***RE: Grading and Drainage Plan for Rio Grande Title Company, Tracts A-1 and 1A
Beverly-wood Addition (J18/D30) Engineer's Stamp Dated 9/8/98.***

TO: Desiderio Salas, Street Maintenance Division
FROM: Susan M. Calongne, P.E., City/County Floodplain Administrator, PWD *SMC*
SUBJECT: **PRIVATE DRAINAGE FACILITIES WITHIN PUBLIC RIGHT-OF-WAY
DRAINAGE FILE NUMBER (J18-D30).**

***RE: Grading and Drainage Plan for Rio Grande Title Company, Tracts A-1 and 1A
Beverly-wood Addition (J18/D30) Engineer's Stamp Dated 6/11/98.***

**RE: RIO GRANDE TITLE COMPANY (J18-D30). GRADING AND DRAINAGE PLAN
FOR PAVING PERMIT APPROVAL. ENGINEER'S STAMP DATED JANUARY
22, 1998.**

DRAINAGE CALCULATIONS
FOR
RIO GRANDE TITLE

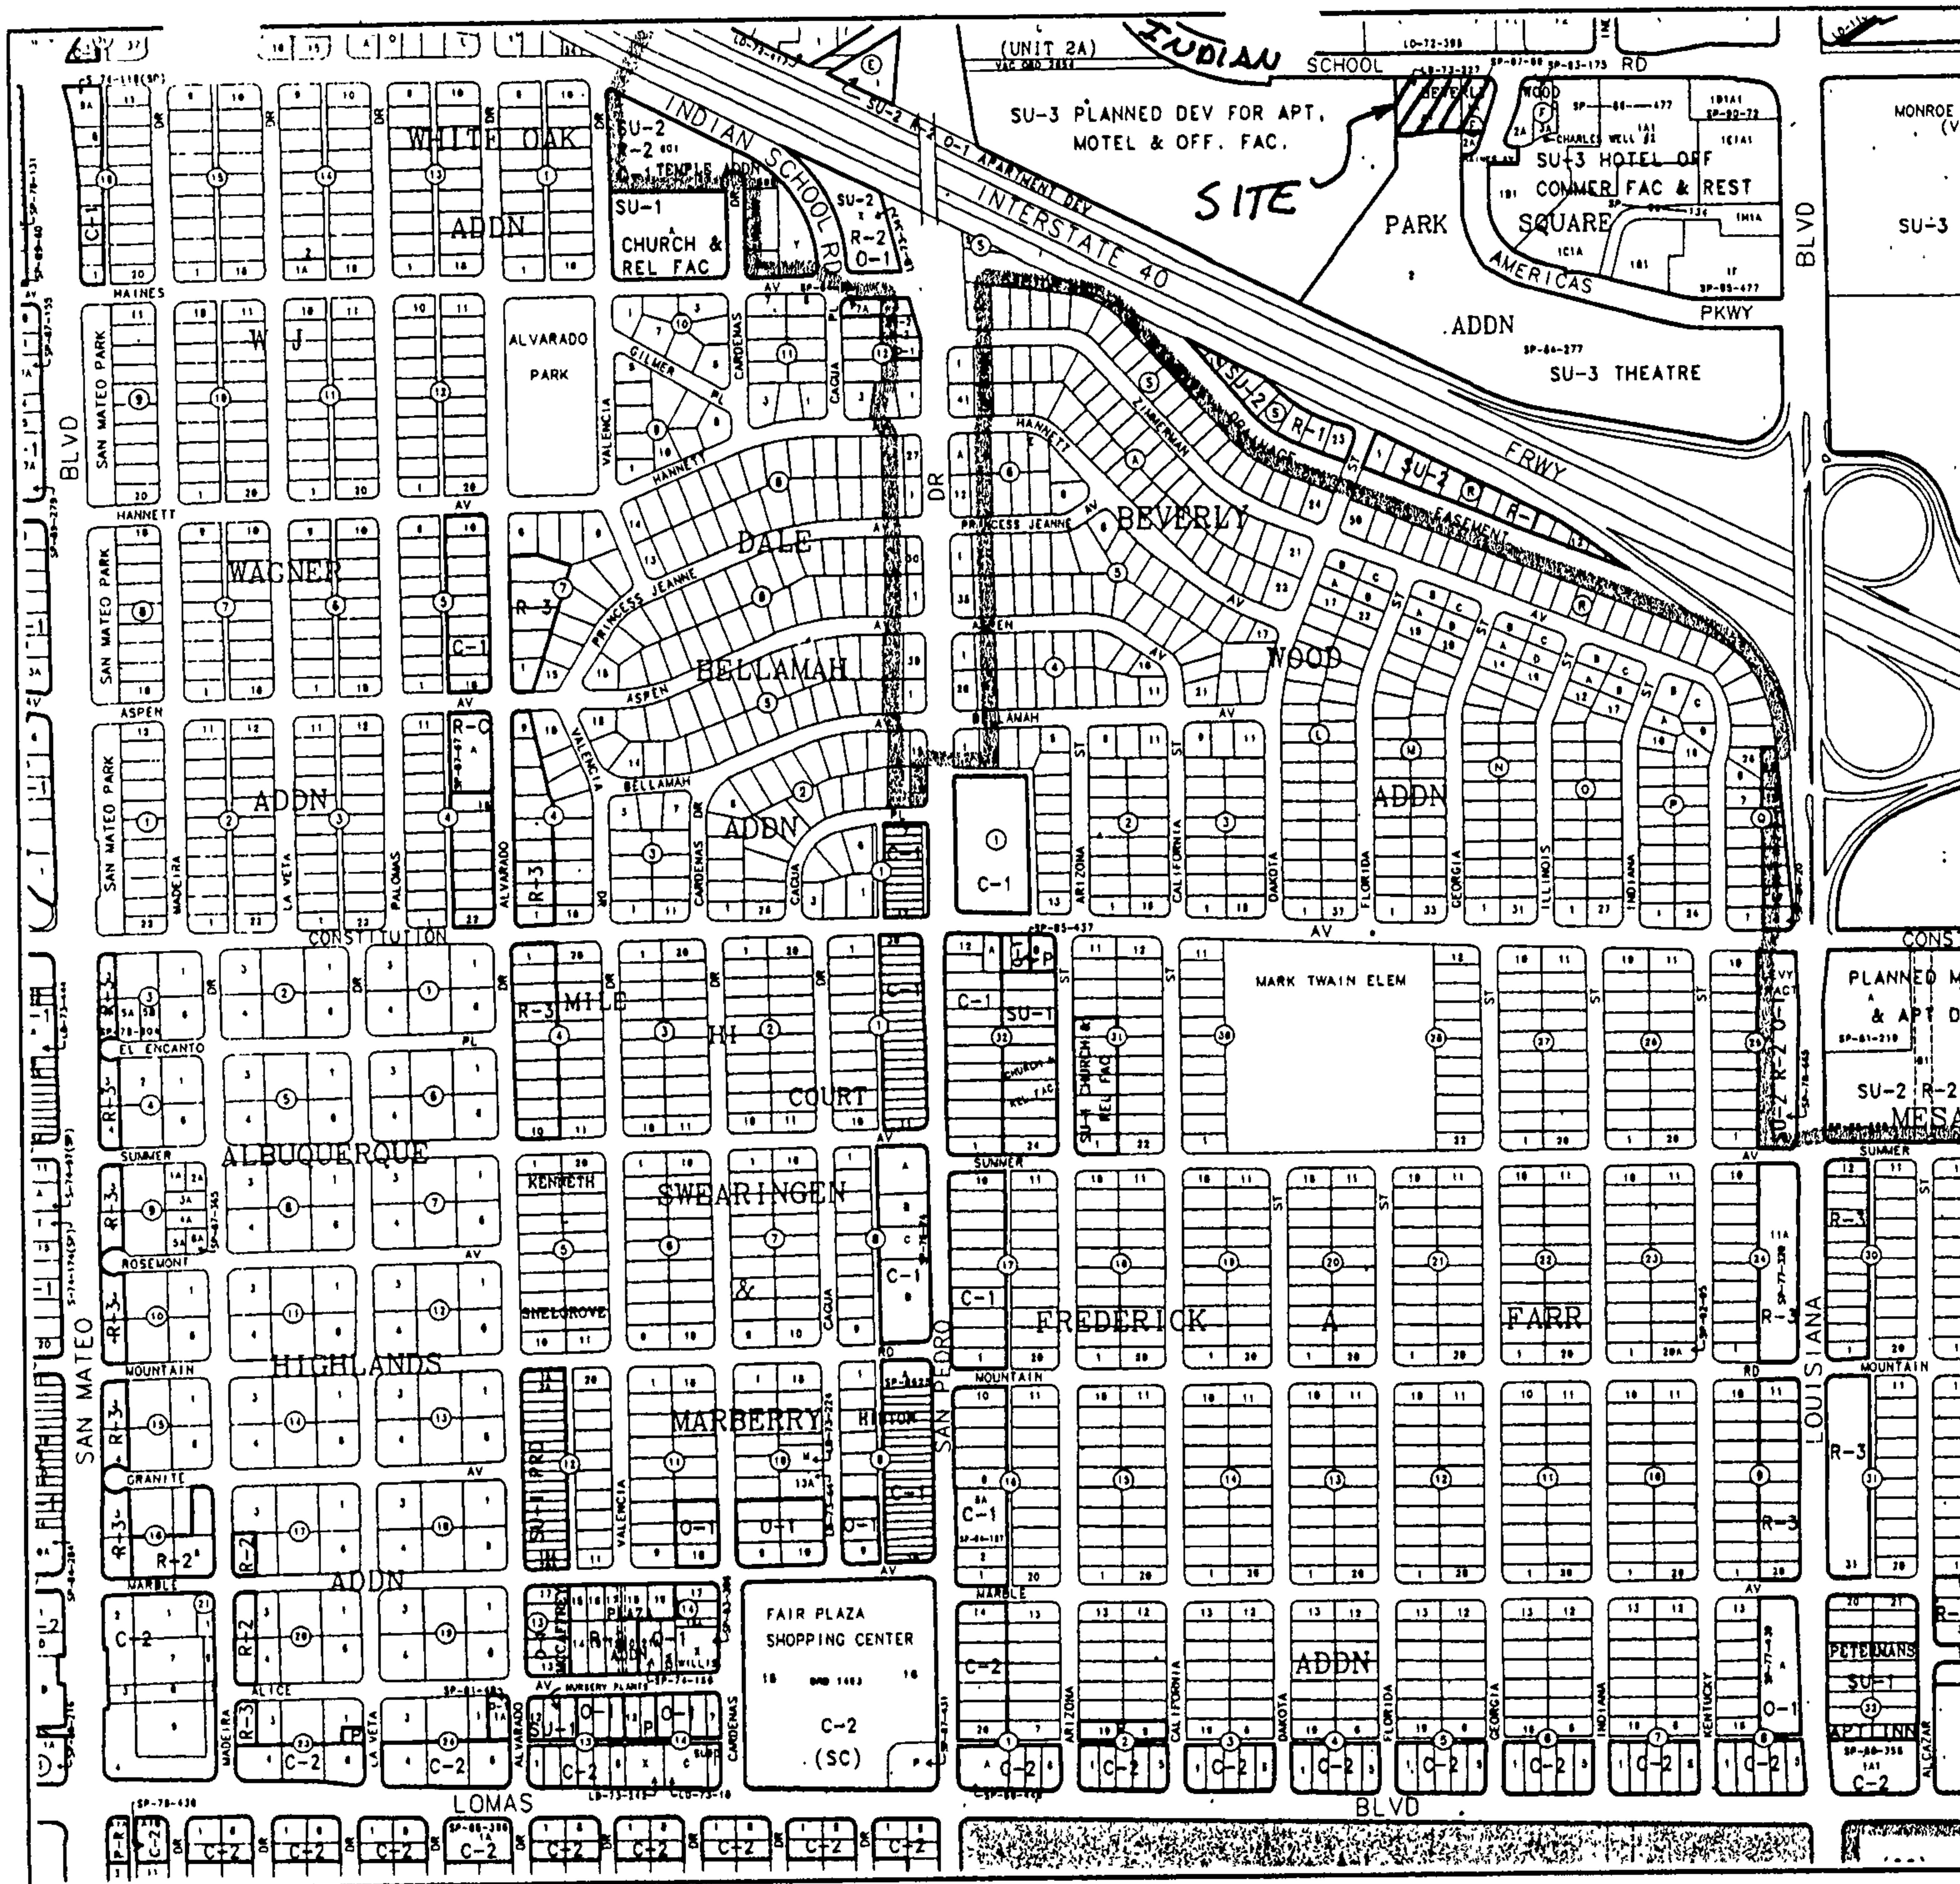
Per my previous letter, I requested a narrative to explain what this plan is being submitted for, off-site flows, downstream capacity and a copy of the proposed plat. I received your fax, however, not the plat. Please make a complete submittal of the plan, with the explanations requested, and attach the plat. I will review the plan as soon as possible, however, for tracking purposes, the submittal must be logged in first.

- SITE DOES NOT LIE IN A 100 YR FLOOD ZONE
- OFFSITE FLOWS DO NOT IMPACT THE SITE
- SITE IS AN EXISTING BLDG WITH PARKING LOT.
THIS REPORT IS FOR AN ADDITIONAL PARKING LOT ON
THE UNDEVELOPED PORTION.

THIS ADDITIONAL FLOW OF 0.29 CFS WILL FOLLOW
THE HISTORICAL PATH INDIAN SCHOOL ROAD TO THE
EXISTING INLET JUST WEST OF THE DRIVEWAY.

SINCE THIS FLOW ENTERS THE SYSTEM BEFORE
THE PEAK THERE IS NO PROBLEM WITH DOWNSTREAM
CAPACITY.

$$H = 0.22' < 0.5 \text{ OK}$$

GRADING & DRAINAGE PLAN

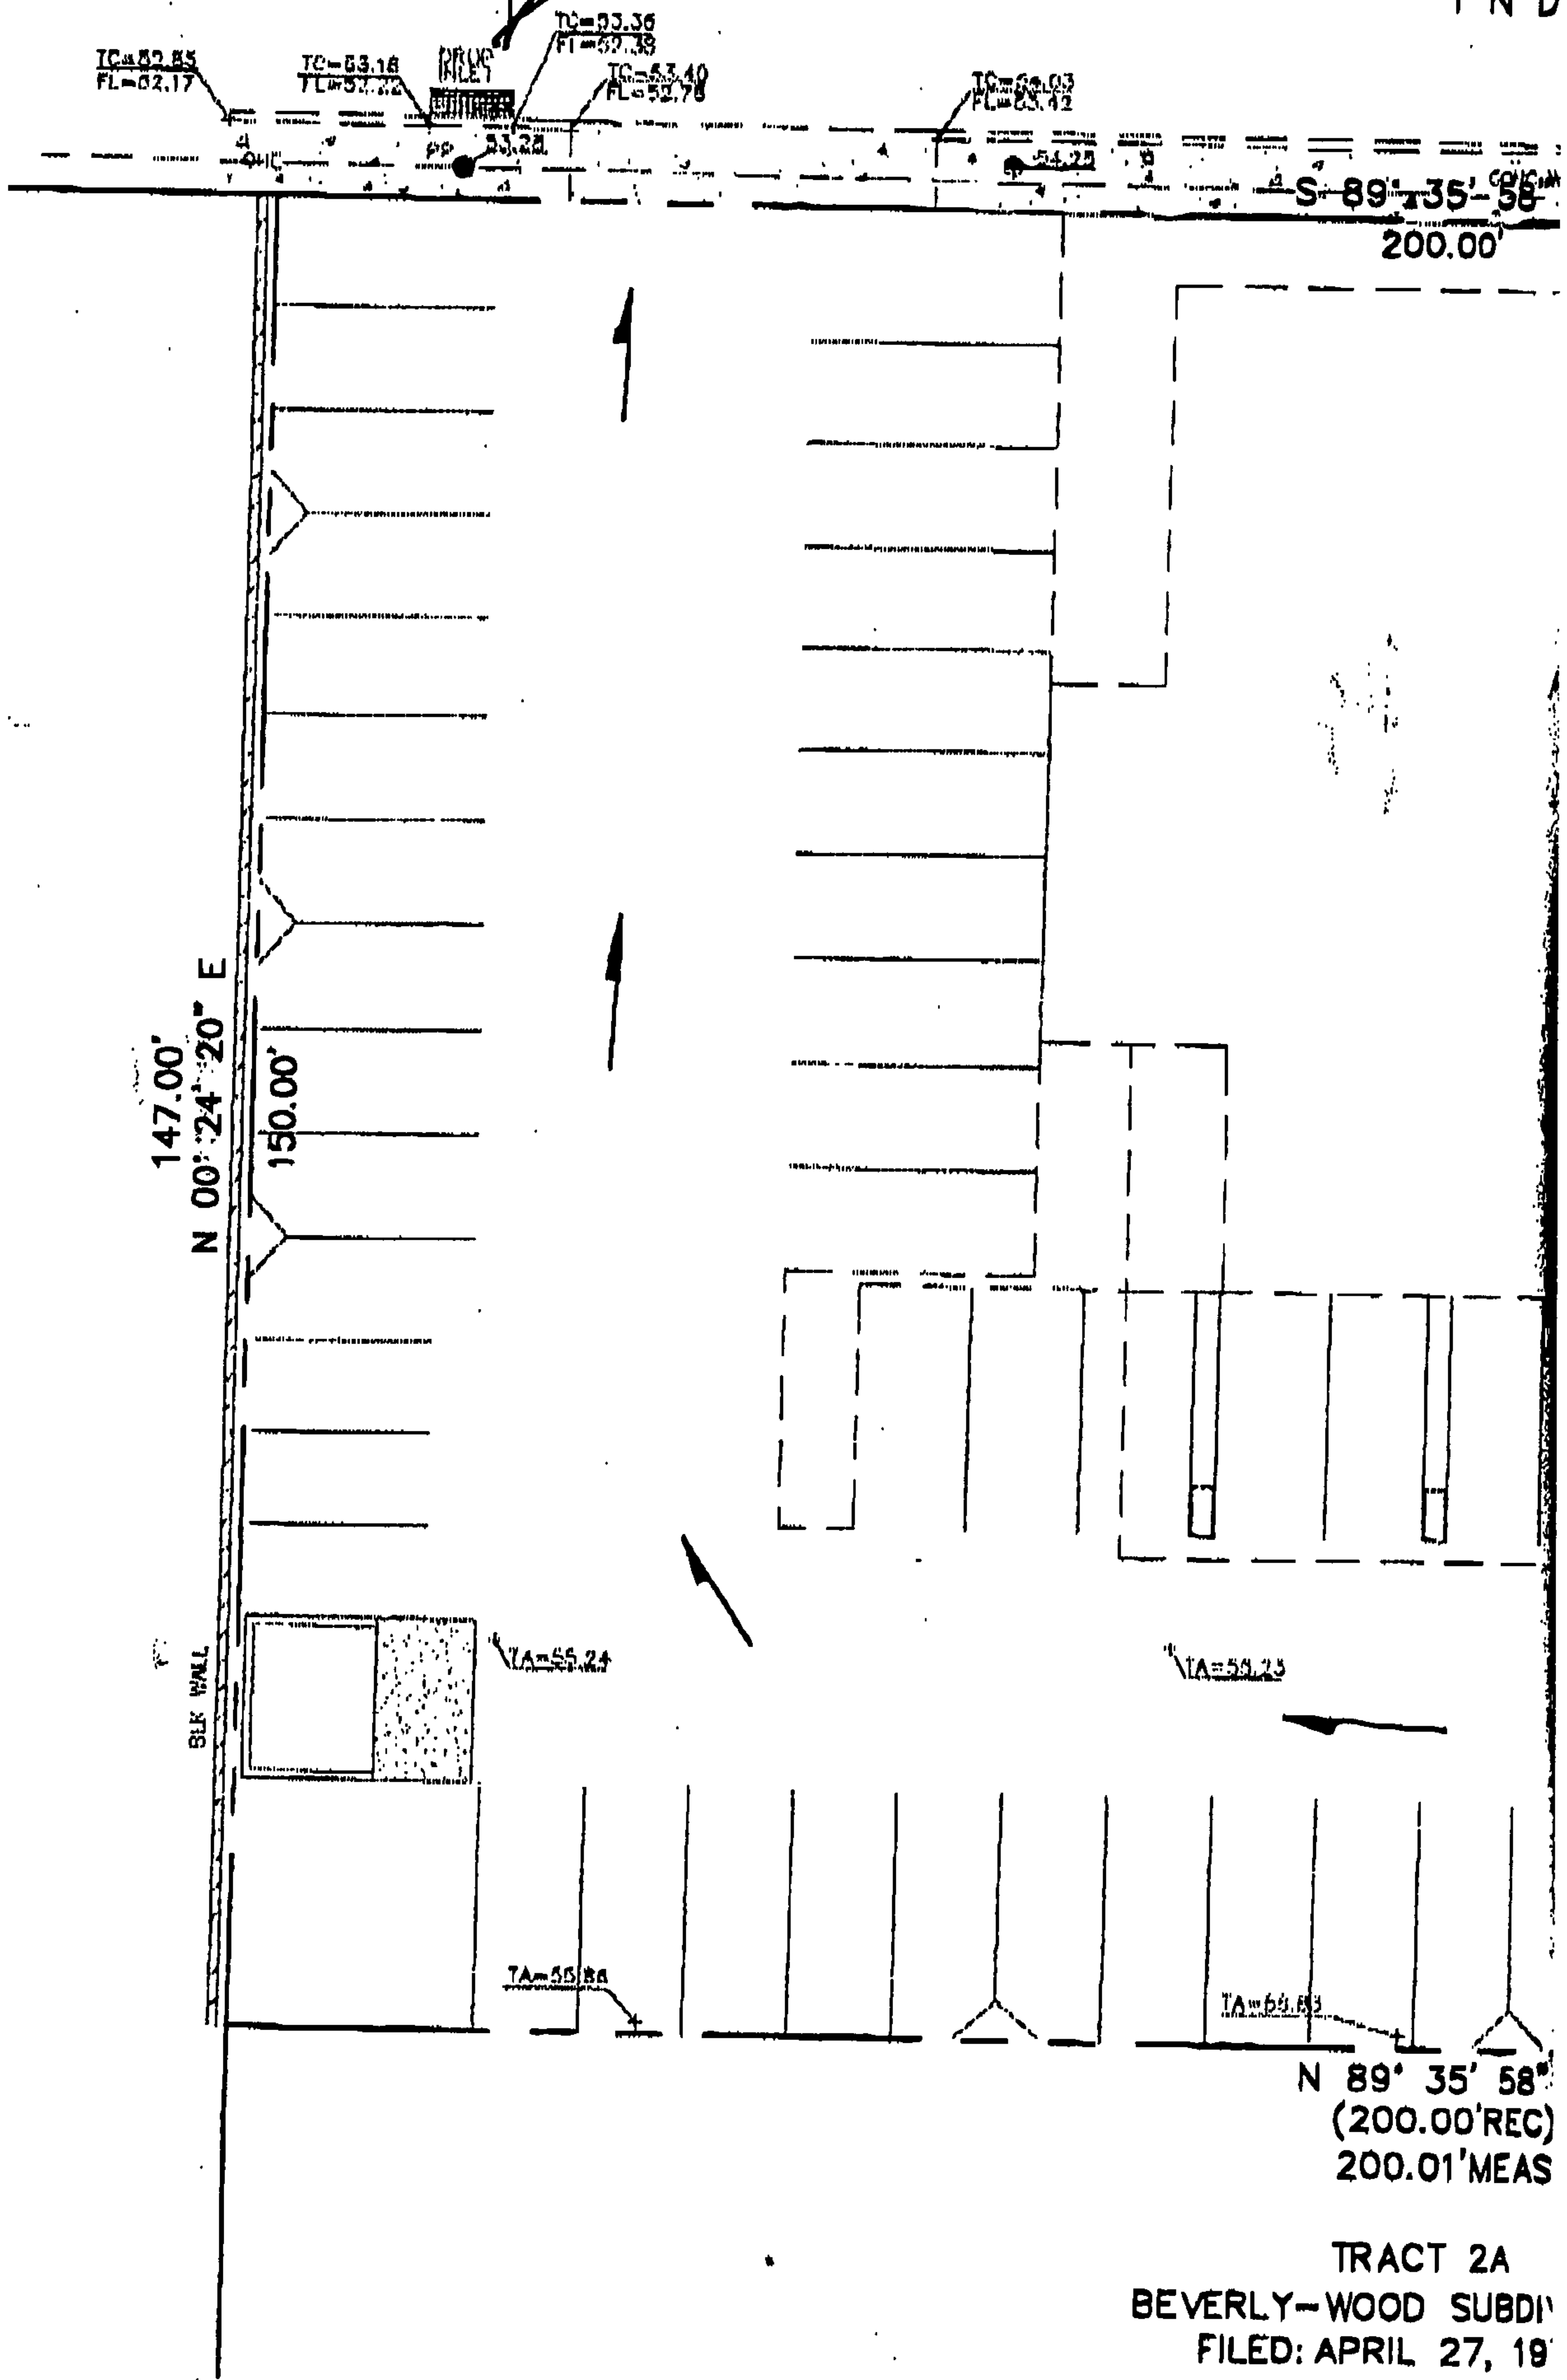
The above referenced Grading and Drainage plan was required to show the existing elevations for the portion of the site that was previously developed. The plan provided on June 12, 1998 showed some existing elevations, however, the copy we received was too light to read any of the numbers. Please resubmit a readable copy of the entire site plan.

The Drainage Information Sheet indicates that the above referenced plan was submitted for Preliminary and Final Plat approval, Site Development Plan for Building Permit approval, Building Permit and Paving Permit approvals. The plan appears to be the same as the one which was approved by Lisa Ann Manwill in February. Please provide a narrative to explain what this plan is being submitted for. Also provide a copy of the proposed plat.

This submittal was not complete and cannot be reviewed. It appears that the plan does not address the entire site. The plan does not address off-site flows or downstream capacity, and does not contain any calculations. Please update the plan and make a complete submittal.

1. *Attached are two copies of the Grading and Drainage Plan that are readable.*
2. *Note number 3 on the plan states that off-site flows do not impact the site.*

3. *Note number 1 on the plan states the existing runoff from the existing tract is 0.32 cfs and the runoff from the developed tract is 0.61 cfs. This results in an increase of 0.29 cfs. This flow follows the same path as the historical flow. The existing 0.32 cfs exited on Indian School Road through a sidewalk culvert and flowed west to the existing curb inlet just west of the driveway. The proposed 0.61 cfs will exit onto Indian School Road through a new sidewalk culvert and flows west to the curb inlet just west of the driveway. This flow enters the drainage system well before the peak flows get to this point. Therefore downstream capacity is not compromised.*

4. *Calculations (AHYMO Runs) are attached.*
5. *We are looking for Final Plat and Paving Permit approval.*
6. *There is no infrastructure requirements for this project.*

Susan -
Please address
this site.
They want to
build.

Flow goes in inlet
